**1** LEACHATE SYSTEM SINGLE LINE DIAGRAM  
SCALE: N.T.S.

**2** MAINTENANCE BUILDING AND INTERMODAL CONTAINER BUILDING  
PARTIAL SINGLE LINE DIAGRAM  
SCALE: N.T.S.

<table><tr> <th>NO.</th> <th>REVISIONS</th> <th>DATE</th> <th>BY</th> </tr><tr> <td>1</td> <td>ISSUED WITH ADDENDUM #4</td> <td>07/19/17</td> <td>JAB</td> </tr></table>

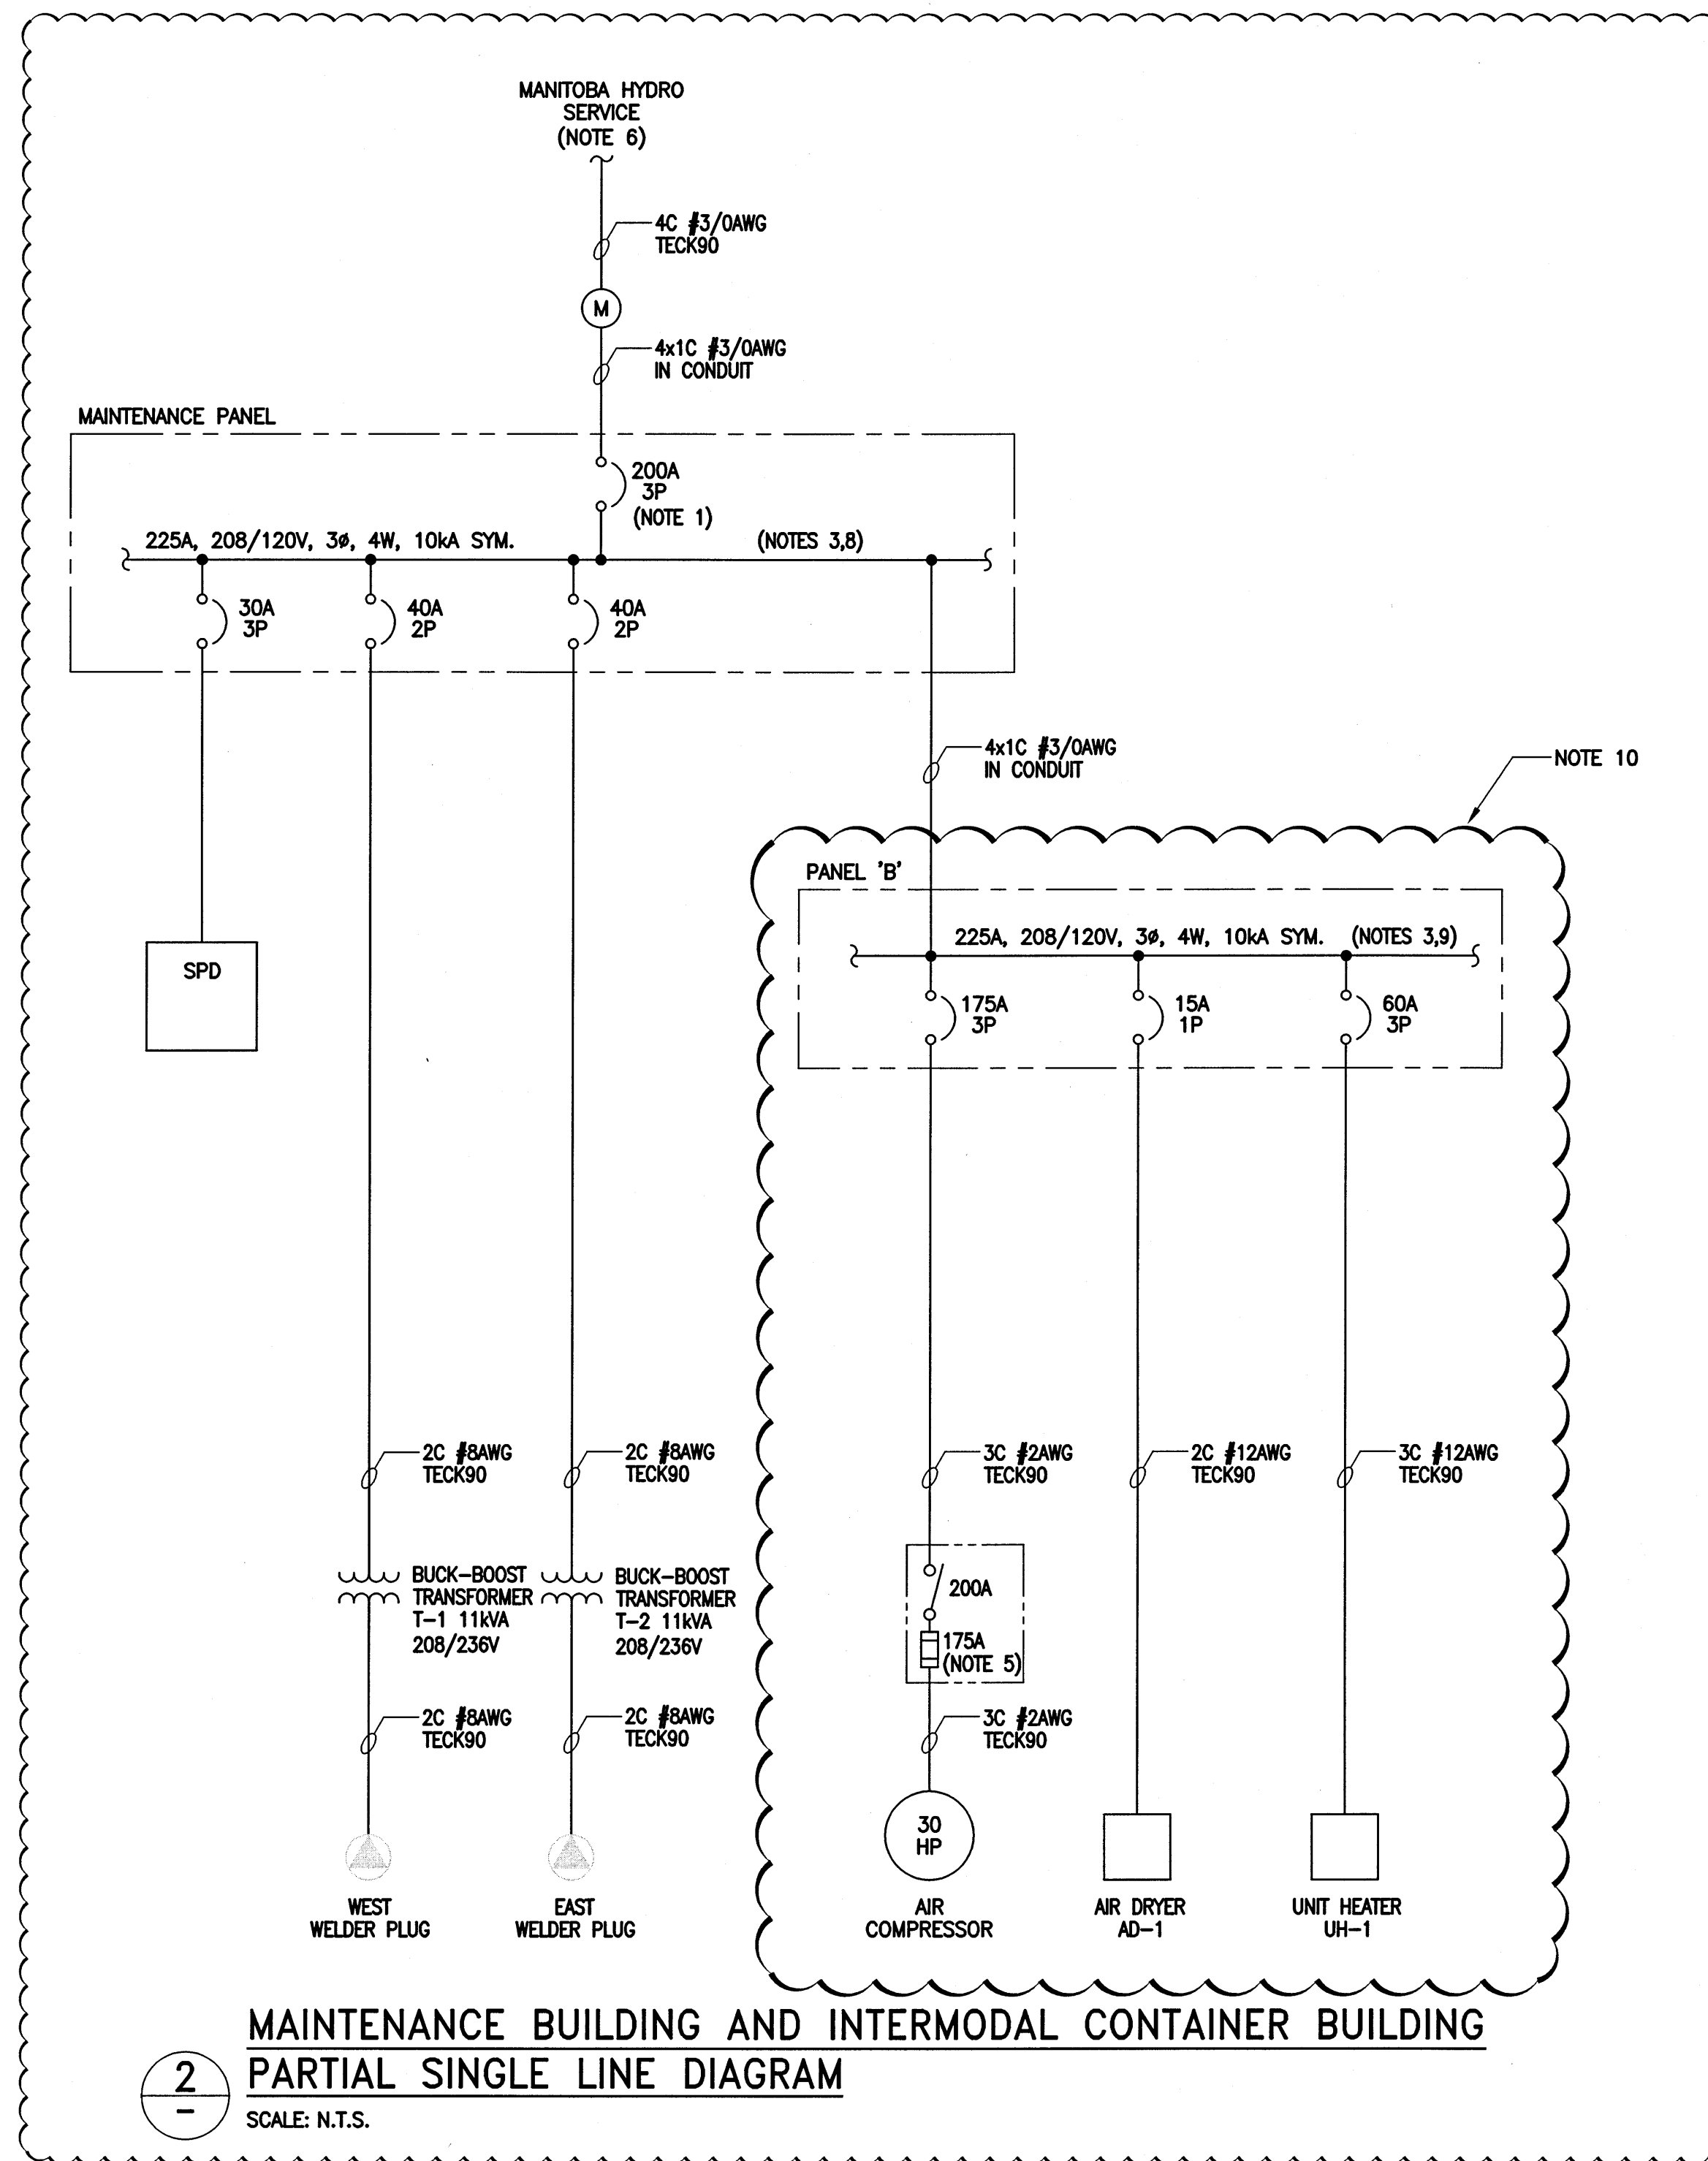
OMMITED FROM THE SCOPE OF BID OPPORTUNITY 448-2017

OMMITED FROM THE SCOPE OF BID OPPORTUNITY 448-2017
